- (a) Does the AESO consider the Transmission Cost Causation Update (TCCU) to be a traditional cost of service study? Please explain your answer.
- (b) If not, why didn't the AESO conduct a traditional cost of service study?

- Preamble:** Reference the NERA Report “Assessment of AESO Transmission Cost of Service Analysis, prepared for the AESO and dated October 31, 2006 (NERA Report). The NERA Report notes that use of NCP for demand-related transmission cost allocation is not common.

Reference: Reference the AESO 2007 GTA Section 4, page 37.

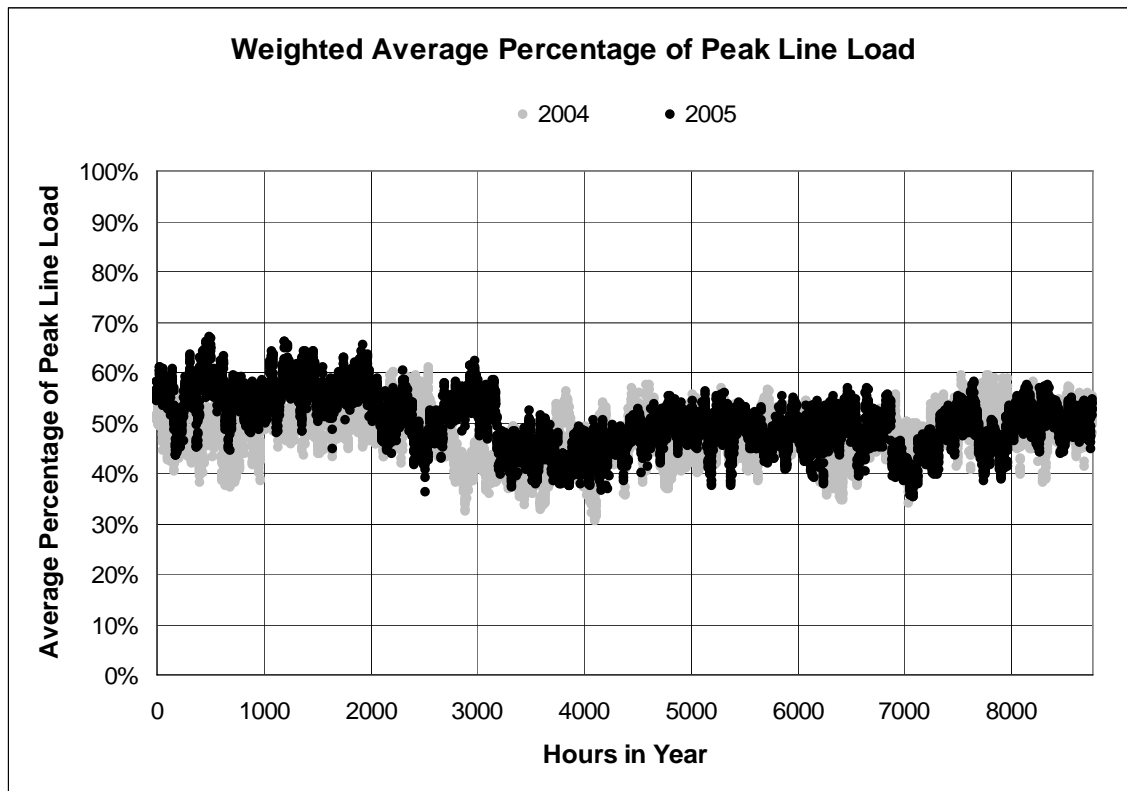
Please provide a chart using the data for Figure 4.6.1 with the load data presented in chronological order rather than as a load duration curve.

Please note that Figure 4.6.1 presented the load duration curves for the weighted average of 240 kV lines from page 17 of the additional analysis of bulk system data, provided on December 13, 2006 as Appendix D to the AESO's 2007 GTA. The average duration curves were calculated as the average of 79 individual duration curves for each 240 kV line. The average duration curve itself cannot be presented chronologically. To produce the chart above, the loading on each line was sorted chronologically and the weighted average was then calculated. This produces a different set of average data points than those presented in Figure 4.6.1.
